Specification Number 2373Storm Damage Repairs along Crow Canyon Road from mile marker 6.0 to mile marker 6.25Responses to Requests for Information

Specification Number 2373

Storm Damage Repairs along Crow Canyon Road from mile marker 6.0 to mile marker 6.25

Responses to Requests for Information

Structural Sketch to accompany response #34

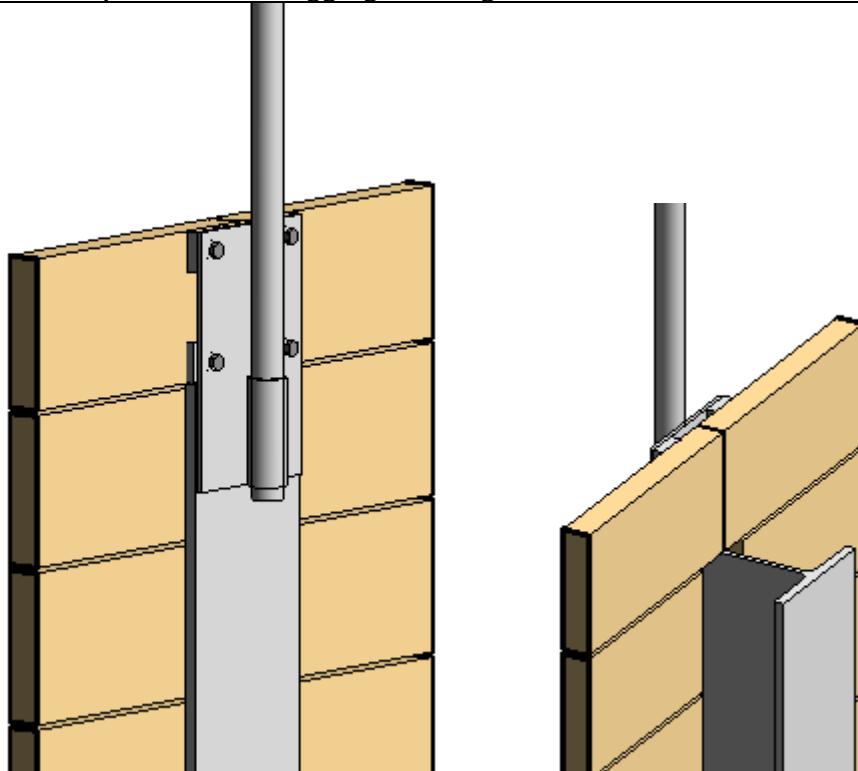
32	1/28/22	What is the depth of the RSP pad.	The RSP depth will be about 2 feet and can be adjusted at the construction site to meet site conditions.
33	1/28/22	Please confirm width & height of plate on Detail (1).	Backer plate width in horizontal direction is steel pile flange width minus 1/2-inch. The top of the pipe sleeve aligns with the top of the steel pile per A/S4, therefore the backer plate height is 8 inches plus the vertical dimension of the top lagging board.
34	1/28/22	<p>Please provide location of lag screw hole from edge of plate corners.</p> <p>Please note that illustration indicate these hole are centers are symmetrical on the perimeter of the plate. Please confirm that this layout will work for all walls that have different cross slopes, see illustration below.</p> <p>: Also the lagging bolt holes are shown at the edges of the plate but Detail (B) on Sheet S3 indicated otherwise, please review and provide clarifications. Finally if backer plate is actually 12" wide, the detail of the wall elevation S1 does not work with W12 type soldier pile beams that are 12" or more per attached cut sheet.</p>	<p>lag screws' centerline is 1.5 inches minimum from backer plate edges &amp; wood edges.</p> <p>Drawings illustrate design intent. Contractor shall apply design intent criteria at each pile to conform to grade condition at each pile and illustrate such on structural steel shop drawings submittal. (note: see structural sketch at bottom of this document)</p> <p>Backer plate horizontal width is 1/2-inch less than steel pile flange width</p>

Here are two 3D views of the top of the pile that may clarify the design intent. The left sketch is the downslope face of the lagging. The right sketch is the backfill side of the wall.
